**CITY OF MERIDIAN
FINDINGS OF FACT, CONCLUSIONS OF LAW
AND
DECISION & ORDER**

Case No(s). H-2024-0038; CR-2024-0003

Conditional use permit (CUP) for a drive-through establishment in a C-G zoning district within 300-feet of existing residential uses and a residential zoning district.

A. Site Plan (date: 8/29/24)

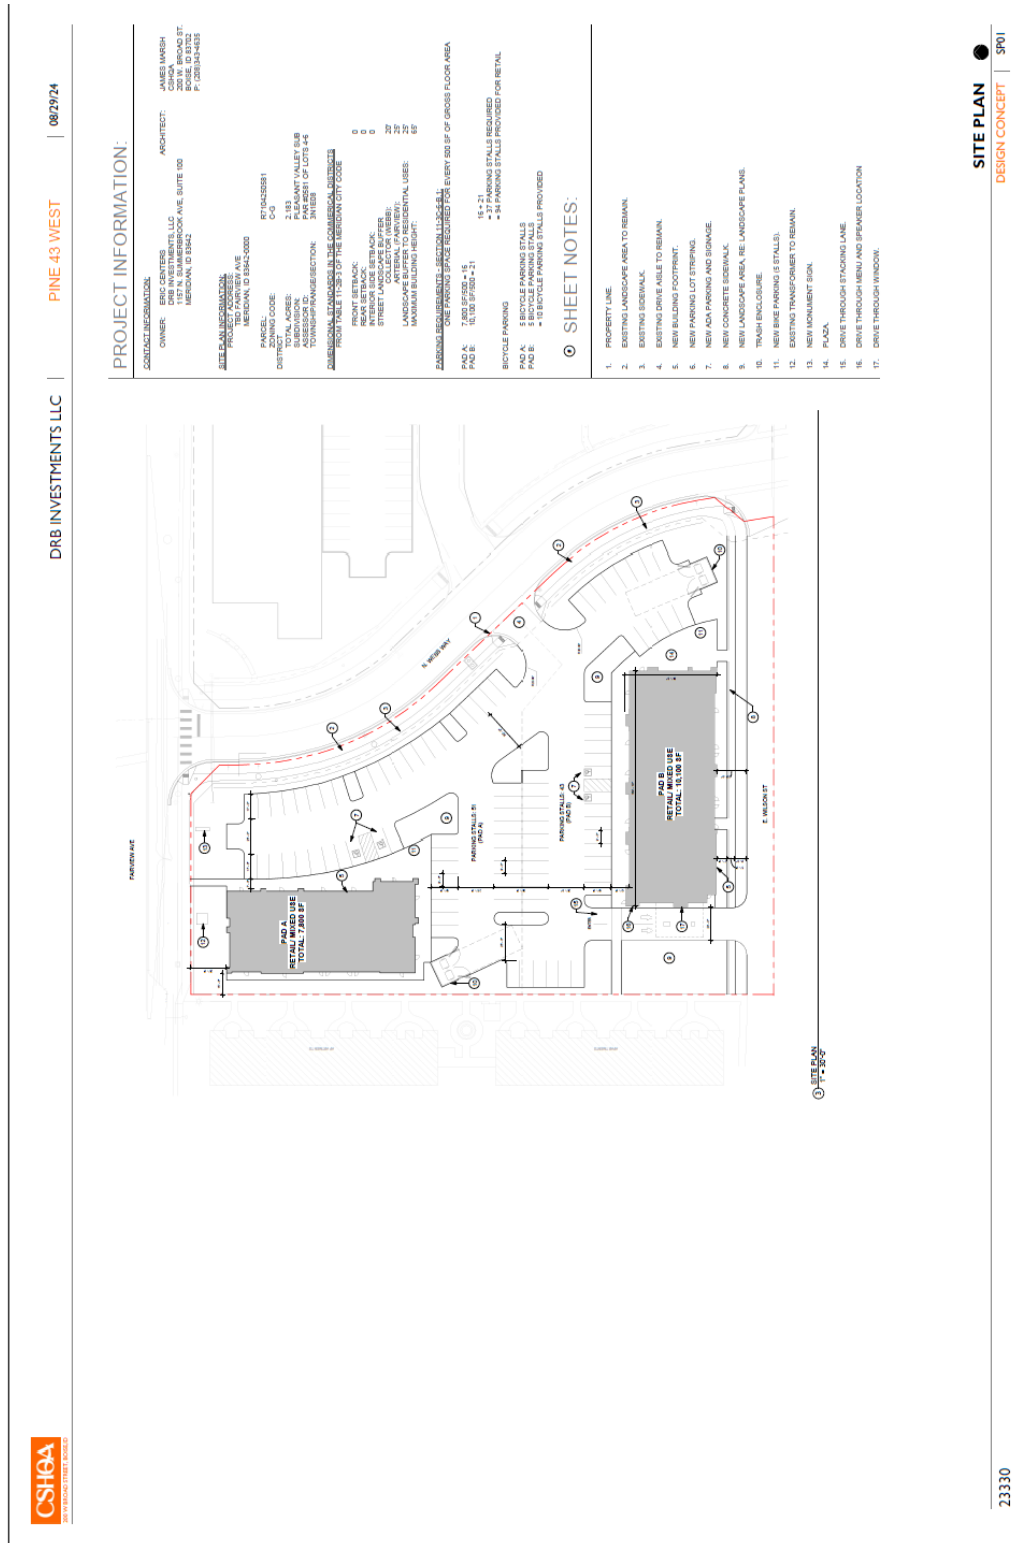
The proposed restaurant features a stacking lane with space to queue approximately three (3) vehicles. Because only pick-up service is anticipated to be provided, this should be adequate queueing; however, Staff does have concerns it may not be if a future use allows drive-up ordering and queueing. The Commission should determine if a re-design is necessary to accommodate more stacking; or if a restriction should be placed on the use (& future uses) to not allow ordering and queueing on-site.

The stacking lane is not located within 10-feet of any residential district or existing residence. A 38-foot wide landscape buffer is provided to residential uses to the west in the area where the stacking lane is proposed to assist in mitigating the noise and fume impacts of the drive; an 11-foot wide escape lane is also proposed between the buffer and the drive-through. A 6-foot tall vinyl privacy fence is proposed along the west boundary of the site for added screening and a covered canopy is proposed in the area above the drive-through window, which should help buffer noise.

The stacking lane is approximately 68-feet in length, which is below the 100-foot requirement for an escape lane; however, an escape lane is provided on the west side of the drive-through lane.

Access (UDC [11-3A-3](#)): The site plan depicts one (1) access drive via N. Webb Way, a collector street, at the eastern boundary of the site; local street access is not available for the site. Direct access via E. Fairview Ave. is prohibited. The escape lane for the drive-through onto E. Wilson St., a collector street, may also be used to exit the site. **Staff recommends signage visible from E. Wilson St. is installed at the exit of the drive-through and the escape lane onto E. Wilson St. notifying motorists that access to the site is prohibited in that location.**

Sidewalk (UDC [11-3A-17](#)): A 5-foot wide detached sidewalk exists on the site along N. Webb Way and E. Fairview Ave., only a curb exists along E. Wilson St.; **a 5-foot wide detached sidewalk is required to be constructed along E. Wilson St., a collector street.**

Trash Enclosure: Two (2) trash enclosures are depicted on the plan to service the overall property – one (1) on Pad A and one (1) on Pad B. **The orientation of the enclosure on Pad A does not meet Republic Services requirements for access and will need to be revised or relocated; the Applicant should work with Republic Services on an alternate acceptable design. Recycling receptacles should be provided in the trash enclosures.**

- b. Install signage before the southern drive-through exit to E. Wilson St. warning drivers to watch for pedestrians crossing the driveway.
 - c. Install signage visible from E. Wilson St. at the exits of the drive-through and the escape lane to notify motorists that access to the site is prohibited in that location.

- d. Include a detail of the bicycle rack that demonstrates compliance with the standards listed in UDC 11-3C-5C.
 - e. Depict a pedestrian walkway with pavers, colored or scored concrete, or bricks across the driveway along the southern boundary of the site in alignment with the sidewalk along E. Wilson St.

- g. Depict a 5-foot wide detached sidewalk along E. Wilson St., a collector street, in accord with UDC 11-3A-17C.
 - ~~h. Correct the Project Information Landscape Requirements on the landscape plan to reflect 13 trees required within the street buffer along N. Webb Way, a collector street, and a minimum of nine (9) trees within the street buffer along E. Wilson St., a collector street; and a 20-foot wide street buffer required along E. Wilson St., a collector street. Note: The width of the driveway maybe subtracted from the street frontage but the vision triangle and seepage bed/storm drainage areas should be included. Trees should be spaced in accord with the standards in UDC 11-3B-7C.4. Depicted on the revised landscape plan.~~

- n. Re-orient or relocate the trash enclosure on Pad A to meet Republic Services requirements for access.
3. Compliance with the standards listed in UDC [11-4-3-11](#)– Drive-Through Establishment and [11-4-3-49](#) – Restaurant is required.

LANDSCAPE PLAN - AREA TWO

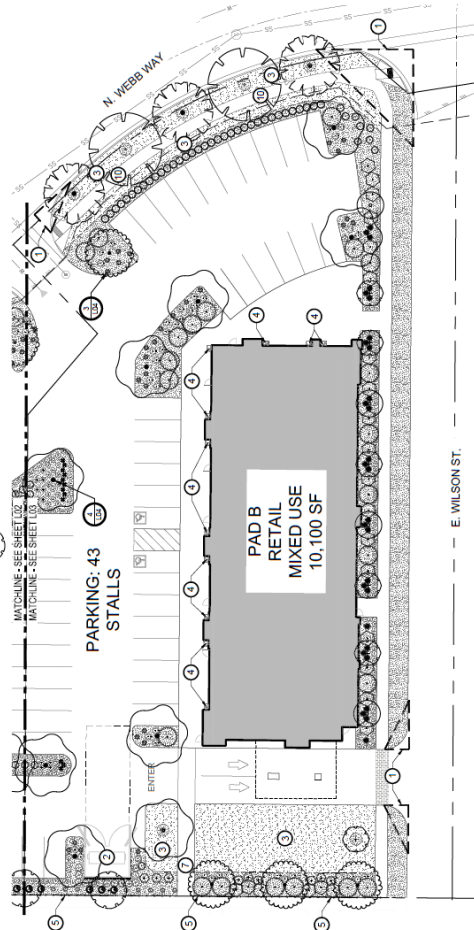
A minimum density of one (1) tree is required per 35-linear feet of frontage along streets – the width of the driveway may be subtracted from the frontage but the vision triangle and seepage bed/storm drainage areas should be included. Trees should be spaced in accord with the standards in UDC 11-3B-7C.4. Where the street buffers are encumbered by easements that prohibit trees, the buffer area is required to include a minimum five-foot wide area for planting shrubs and trees outside of the easement as set forth in UDC 11-3B-7C.1b. The Project Information Landscape Requirements on the

landscape plan should be revised to reflect 13 trees required within the street buffer along N. Webb Way, a collector street, and a minimum of nine (9) trees within the street buffer along E. Wilson St., a collector street; and a 20-foot wide street buffer required along E. Wilson St., a collector street. A revised landscape plan should be submitted that includes the additional trees and these revisions.

A minimum 25-foot wide buffer is required along the west boundary of the site adjacent to existing residential uses per UDC Table 11-2B-3, landscaped in accord with the standards listed in UDC 11-3B-9C. **The Applicant requests approval of a reduced buffer width along the northern portion of the west boundary of the site ranging from 5 to 10-feet adjacent to parking and the rear of the building on Pad A (a 38-foot wide buffer is proposed directly adjacent to the drive-through on the southern portion of the west boundary). Staff recommends the 5-foot buffer adjacent to parking is widened to 7-feet and the length of the abutting parking spaces are reduced to 17-feet, which allows 2-feet of vehicle overhang (and increases the width of the buffer) in accord with UDC 11-3C-5B.4. A reduced building setback of 15-feet is also requested for the northern building based on the reduced buffer width.** The UDC allows City Council to modify the buffer width at a public hearing with notice to surrounding property owners *if determined appropriate*; a reduction in the buffer width does not affect building setbacks – all structures are required to be set back from the property line a minimum of the buffer width required in the district (i.e. 25'), per UDC 11-3B-9C.2. *Note: Staff is in the process of proposing an amendment to the UDC, which would allow buildings to encroach in the buffer area if consent from the abutting property owner is obtained and if Council grants a reduction to the buffer width. In the interim of a code change, the Director has determined a building can encroach within the required buffer area IF Council grants a reduction to the buffer width AND a reduced setback AND consent from the adjacent property owner is obtained for the buffer and building setback to be reduced.* ~~**The Applicant should pursue obtaining consent from the abutting property owner for a reduced building setback based on the reduced buffer width for consideration by Council with the request for a reduced buffer.**~~

- j. Depict shrubs and other vegetative groundcover along with trees *within* the 20-foot wide buffer along N. Webb Way at the back side of the sidewalk in accord with UDC 11-3B-7C.3, instead of outside the buffer where vehicles will overhang beyond the parking spaces, which may result in damage to the shrubs/plantings.

- m. ~~Depict a 25-foot wide buffer to residential uses along the west boundary of the site as set forth in UDC Table 11-2B-3; or, submit and obtain approval of an application for City Council review of the Commission's (or Director's decision on a Certificate of Zoning Compliance application) decision to reduce the width of the buffer (and building setback) as allowed by UDC 11-B-9C.2 and as determined by the Director. The City Council approved a subsequent request for City Council review of the Commission's decision granting a reduced buffer width of 7-feet adjacent to parking and 10-feet adjacent to the rear of the future single-story building on Pad A along the west boundary of the site with a reduced building setback of 15-feet with the provision of privacy fencing and increased plantings within the buffer as requested by the abutting property owner to the west.~~

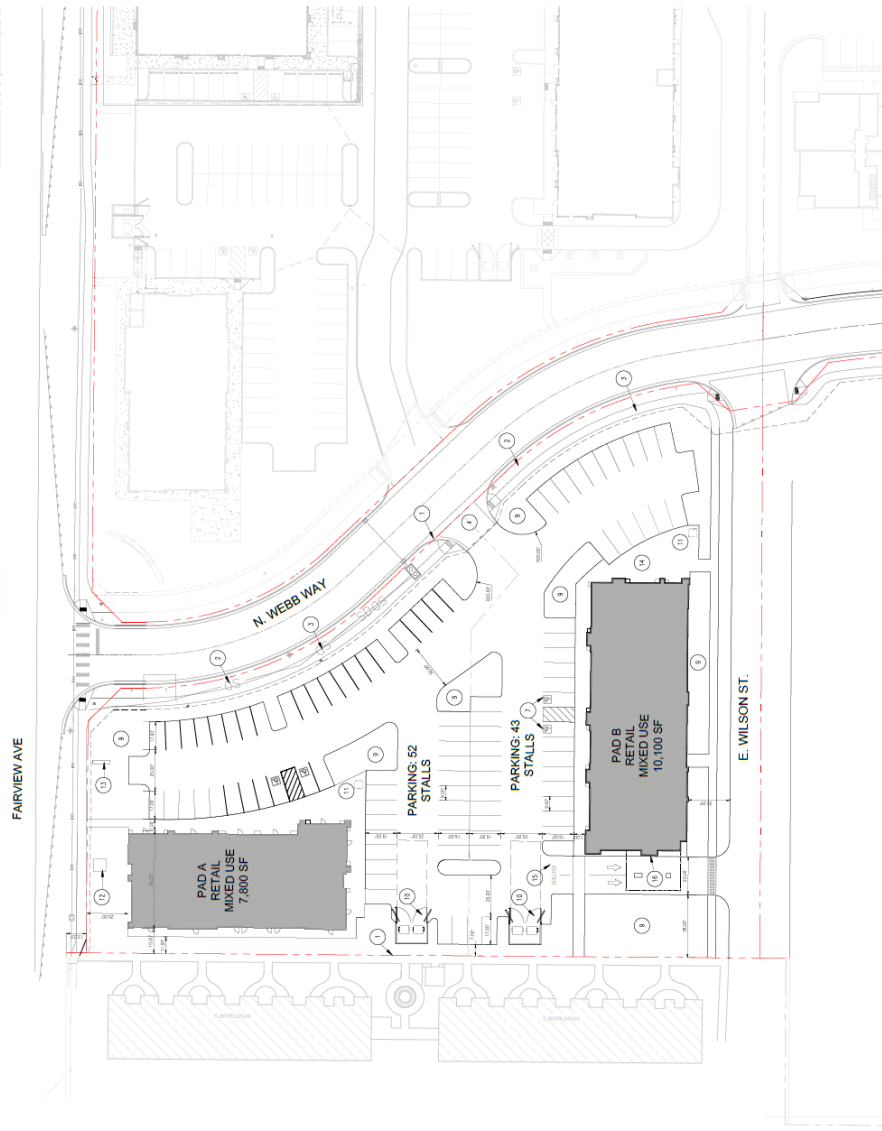
Approved Use: The drive-through is for a restaurant which is planned in the western-most tenant space of a new 10,100-square foot multi-tenant building on the southern portion of the site on Pad B (see site and landscape plans below). The drive-through was approved for pick-up service only; a menu board and/or speakers was not approved.

UDC Requirements: The UDC (Table 11-2B-3) requires a 25-foot wide landscape buffer to residential uses on C-G zoned property sharing a contiguous lot line with a residential use; landscaping is required within the buffer in accord with the standards set forth in UDC 11-3B-9C. Because the abutting property to the west contains a multi-family residential use and the subject property consists of one (1) parcel of land, a buffer is required along the entire western boundary of the site. However, the UDC does allow the width of the buffer to be modified by City Council at a public hearing with notice to surrounding property owners; a reduction in the buffer width does not affect building setbacks – all structures are required to be set back from the property line a minimum of the buffer width required in the district (i.e. 25'), per UDC 11-3B-9C.2.

Staff is in the process of proposing an amendment to the UDC, which would allow buildings to encroach in the buffer area if consent from the abutting property owner is obtained *and* if Council grants a reduction to the buffer width. In the interim of a code change, the Director has determined a building can encroach within the required buffer area *if* Council grants a reduction to the buffer width and a reduced setback *and* consent from the adjacent property owner is obtained for the reduced buffer and building setback. A letter of support for the reduced buffer width and associated building setback was submitted from the owner of the abutting residential property provided that a privacy fence and increased plantings are completed along the west boundary of the site, which will provide visual and sound buffering to the residential units.

- 4. City Council change(s) to Commission recommendation:
 - a. Council approved the Applicant's request for a reduced buffer width of 7-feet adjacent to parking and 10-feet adjacent to the rear of the future single-story building on Pad A with a reduced building setback of 15-feet with consent from the abutting property owner contingent upon the provision of privacy fencing and increased plantings within the buffer as proposed.
